Subject: V. C. Summer Nuclear Station Units 2 and 3  
Docket Numbers 52-027 and 52-028  
Combined License Application – Response to NRC  
Environmental Report (ER) Requests for Additional Information  
(RAI): TLine-2 and 3

**VCSNS UNITS 2 and 3  
Environmental Report Review  
Response to NRC Requests for Additional Information**

**NRC RAI Number:** RAI TLine-2 **Revision:** 0

**NRC RAI Number:** RAI TLine-3 **Revision:** 0

**TRANSMISSION LINE SITING PROCESS**

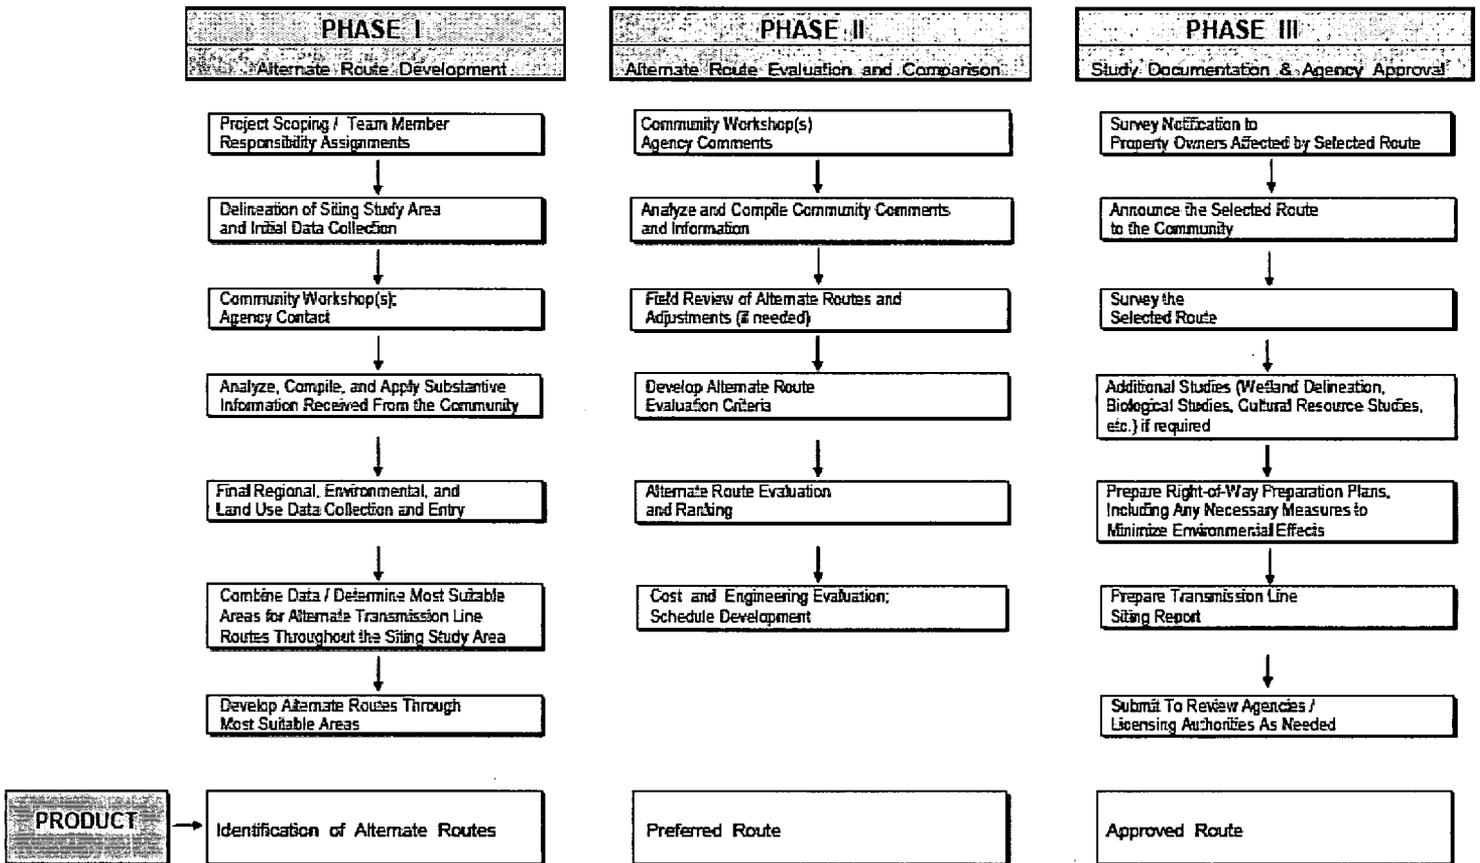
Provide the following information in reference to the projected transmission line construction and operation:

3. A list of and schedule for environmental reviews that will be conducted as part of the transmission line siting procedure
4. Standards/procedures for the interconnection operation and the right-of-way maintenance

The following is a chart displaying SCE&G's transmission line siting process.

In summary, environmental planning is not merely a "review procedure" in SCE&G's transmission line siting process; rather, it is integral to every step in the process from initial data gathering to final route selection and continues through actual line construction. The design of the siting process ensures that selected routes are ones that minimize affects to environmental, cultural, land use, and aesthetic resources. Moreover, the process is traceable to ensure that the decision making rationale can be reviewed in any permitting or licensing proceeding. This traceability is
